MAINE TURNPIKE AUTHORITY

ADDENDUM NO. 2

CONTRACT 2019.10

BRIDGE REPLACEMENT
WARREN AVENUE OVERPASS (MILE 49.0)

WARREN AVENUE OVERPASS
BRIDGE REPLACEMENT
STORMWATER UNDERDRAIN TREATMENT
SWALE DETAILS

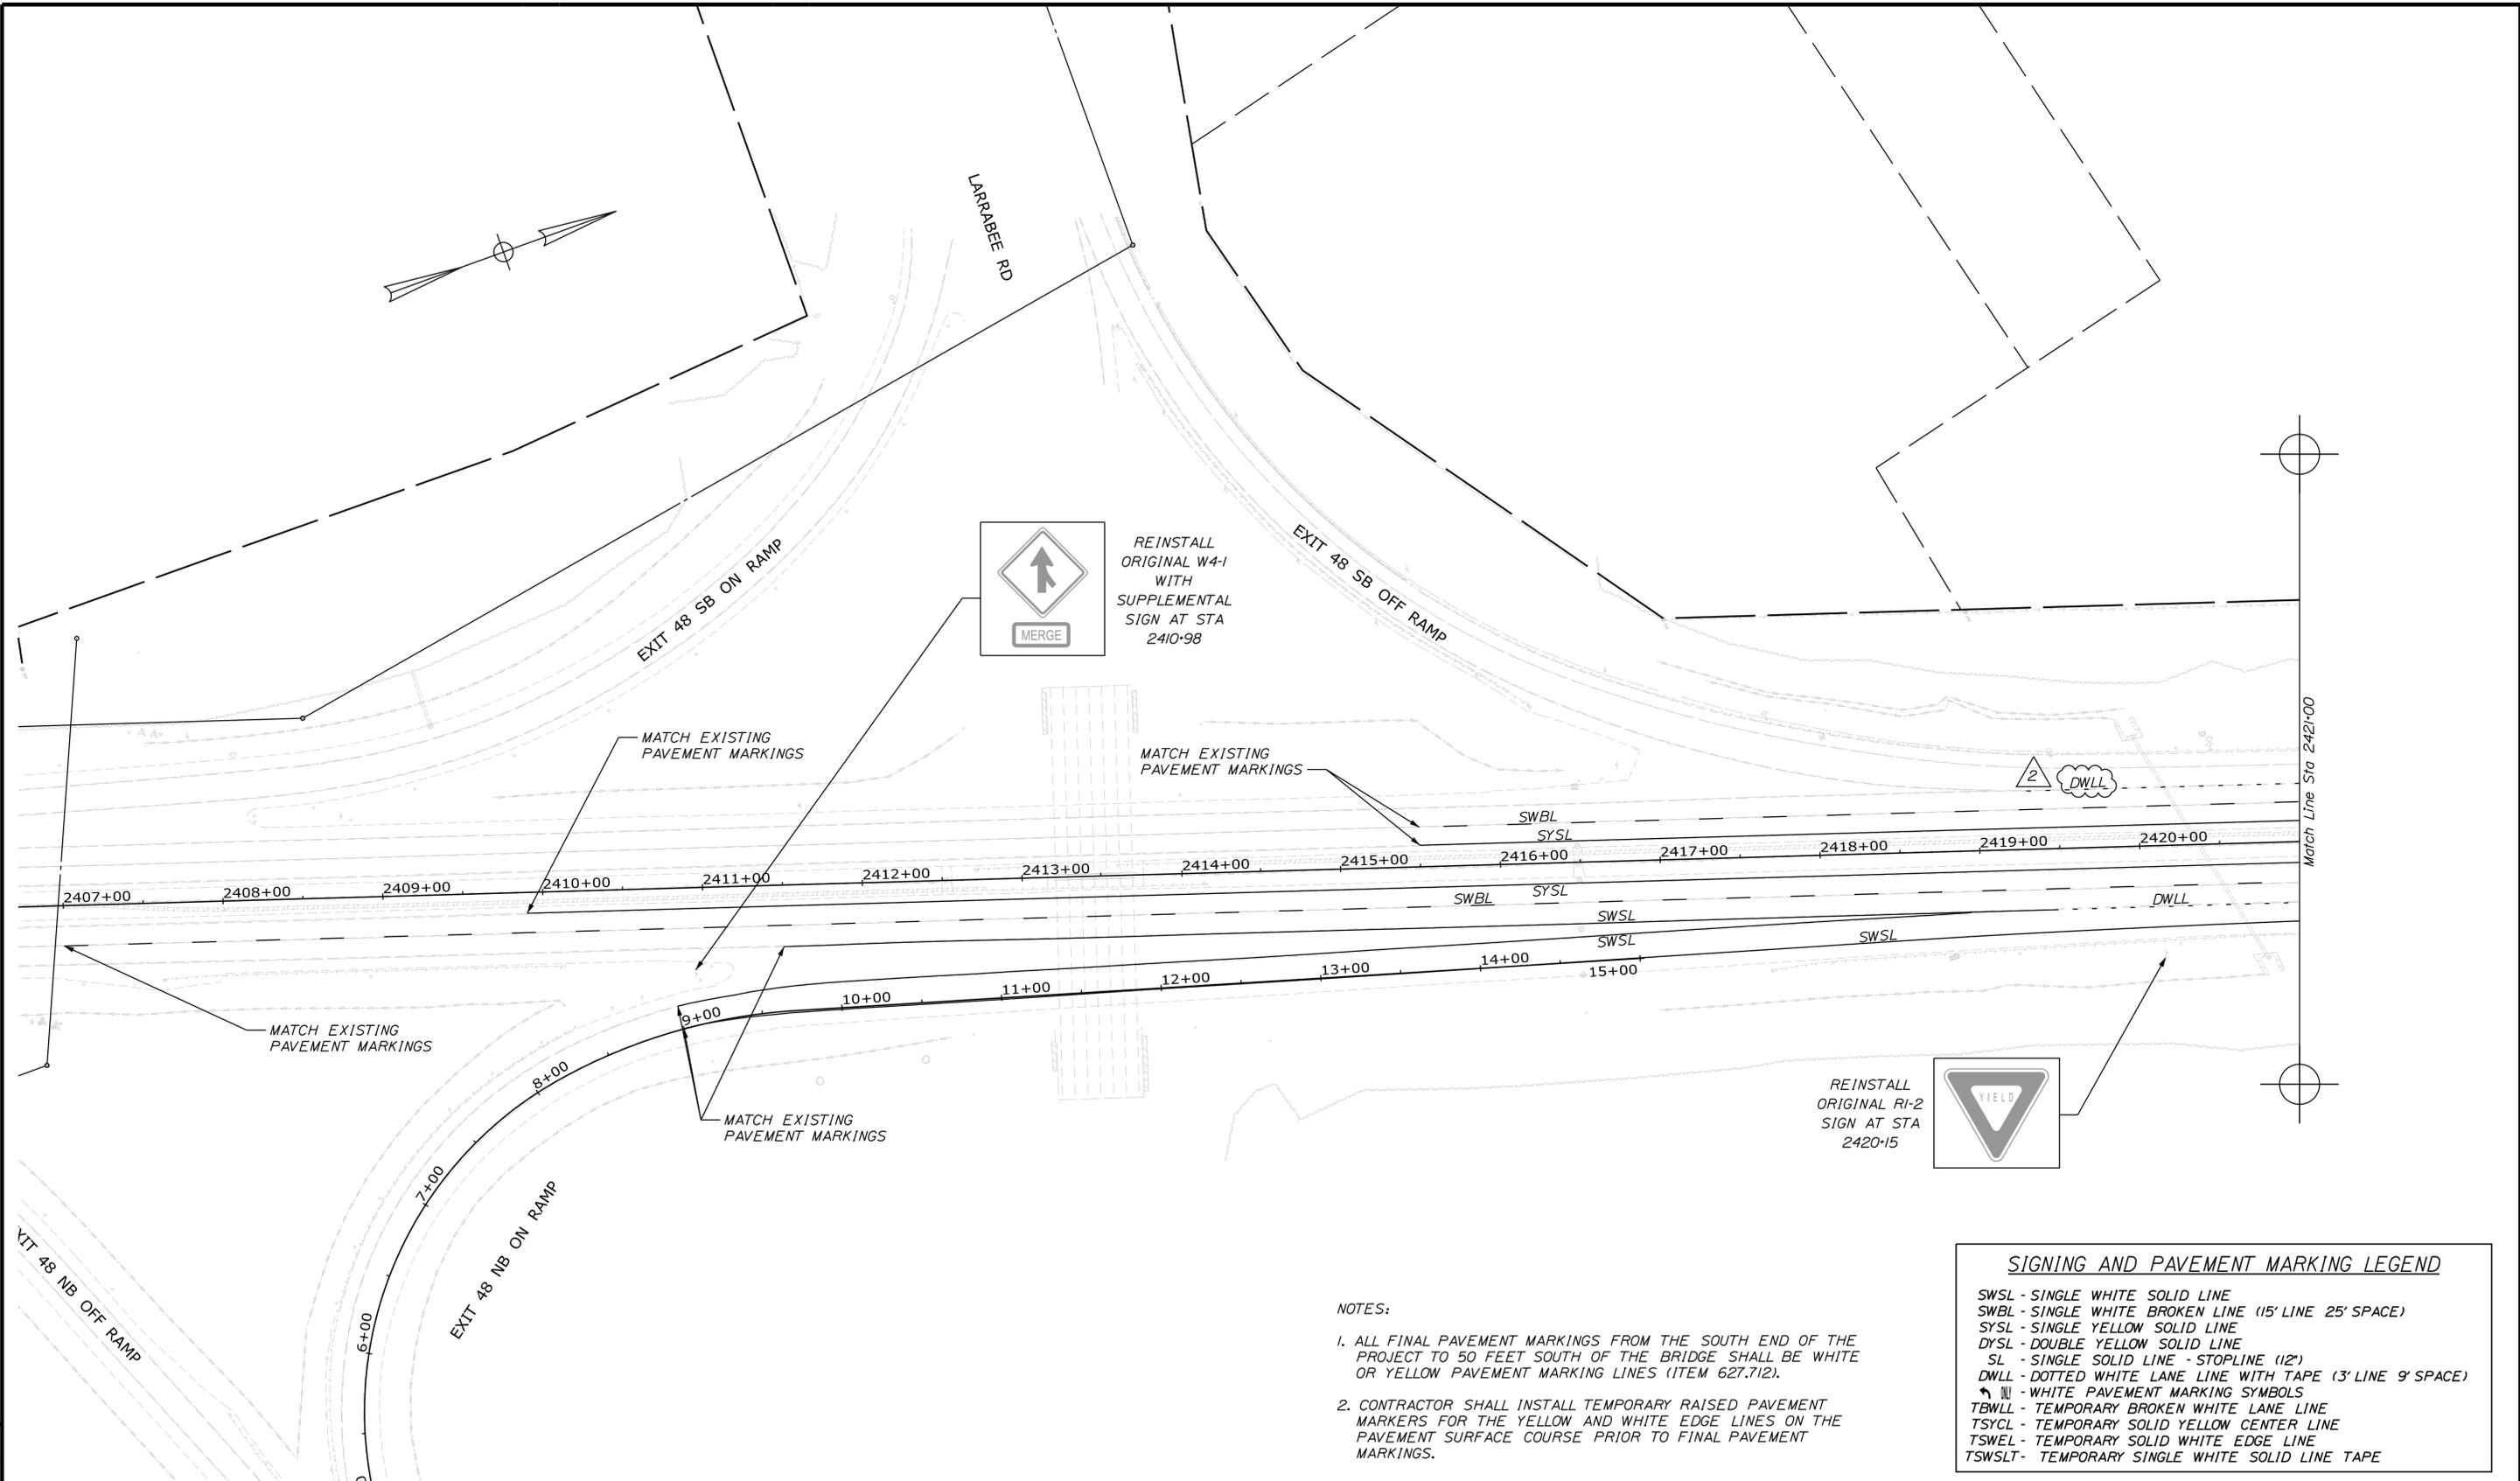
- Question 13: Drawing Sheet 15 Note 4 states that a 10 mil HDPE liner shall be used in the underdrain treatment swale and that the liner shall meet requirements of Special Provision 620.02. Special Provision 620.02 states the HDPE Geo-membrane shall be 40 mil HDPE. Please clarify.

- Response: *The HDPE Geomembrane shall be 40 mil. This has been clarified on the attached revised Contract Plan sheet 15.*

- Geotextile fabric shall conform to MaineDOT Specification 722.02 - Class A designation.
- A 40 mil HDPE liner shall be installed along the entire length of the underdrain treatment swale around the underdrain bedding and swale bed media as shown on the detail. The liner shall meet Special Provisions 620.02, HDPE Geomembrane, and shall be paid for under Item 620.70.

**WARREN AVENUE OVERPASS
 BRIDGE REPLACEMENT
 SIGNING AND STRIPING PLANS (2 OF 4)**

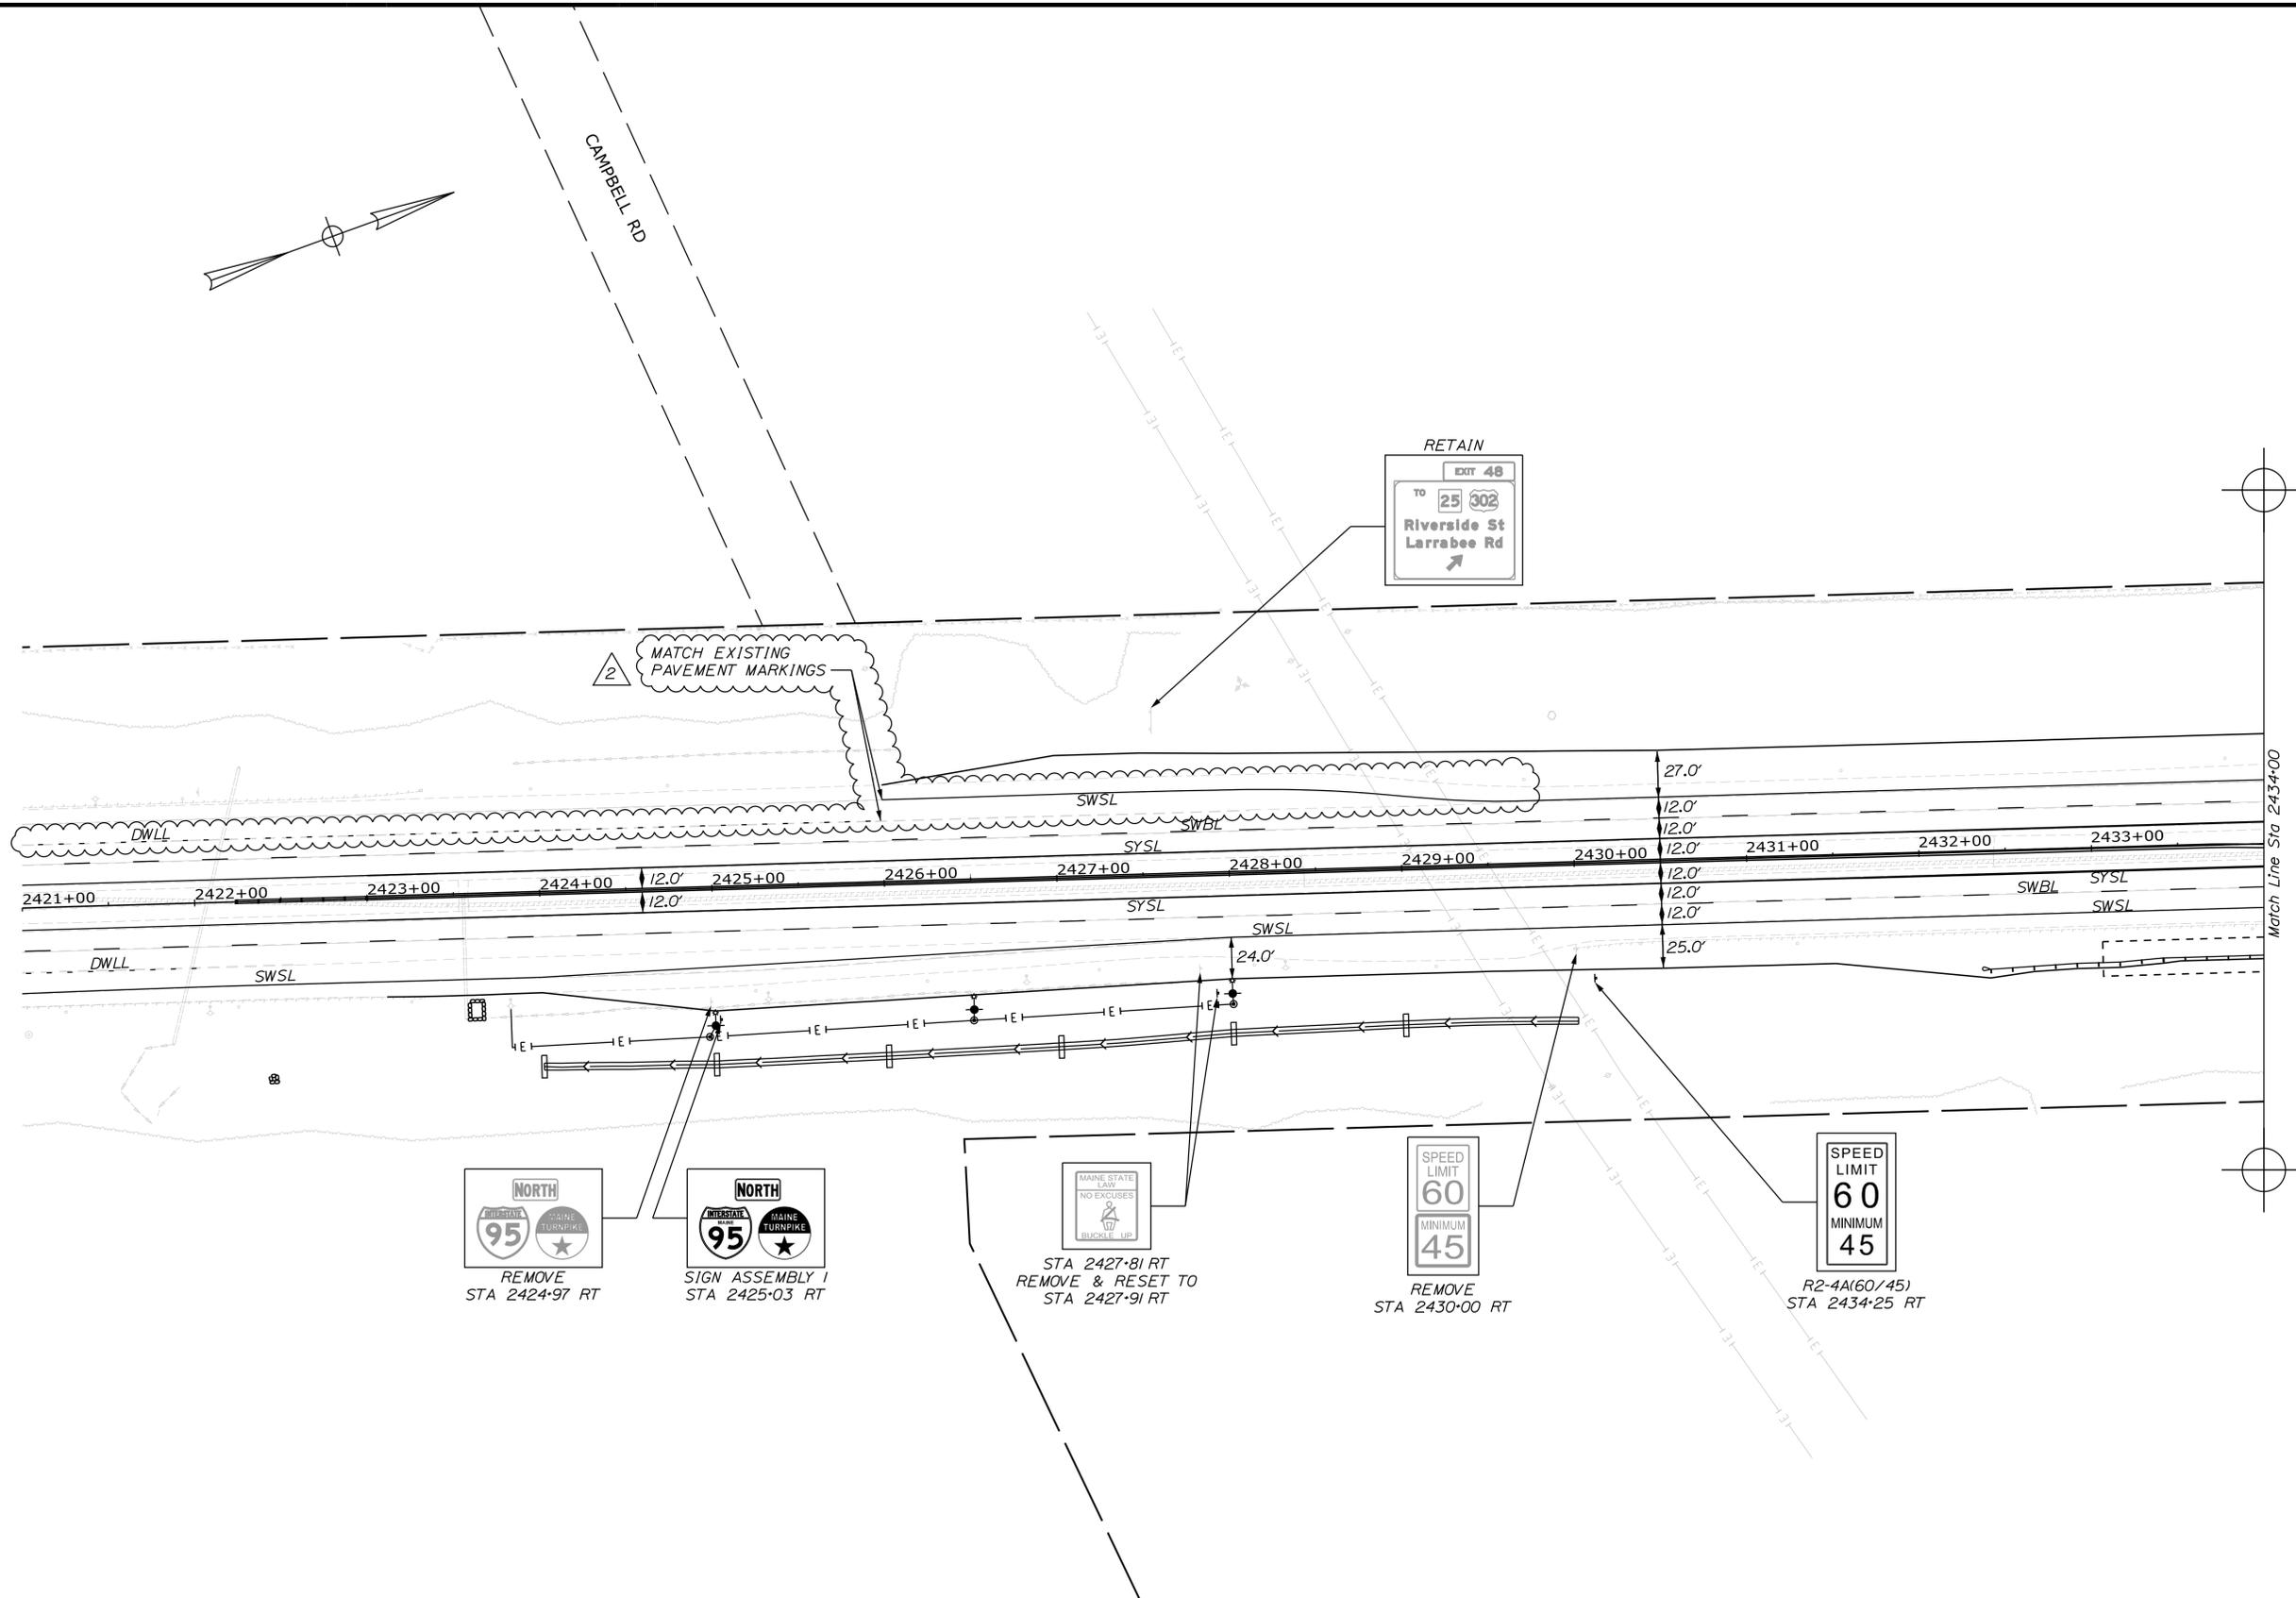
Question 2: Page 59 of the plans shows that all lines up to 50 feet south of the bridge shall be paint. This sections includes the only DWLL in the project for the acceleration lane of the on-ramp. This appears to be in conflict with the Contract Book.

Response: *The special provision is a typical special provision for Pavement Marking Tape and the Dotted White Lane Line Tape. Due to future planned work, all pavement markings south of 50 feet south of the bridge shall be white or yellow paint using Item 627.712, including the SWSL, SYSL, SWBL, and DWLL. Minor changes have been made to the attached Contact Plan sheets 58 and 59 to further clarify pavement markings.*
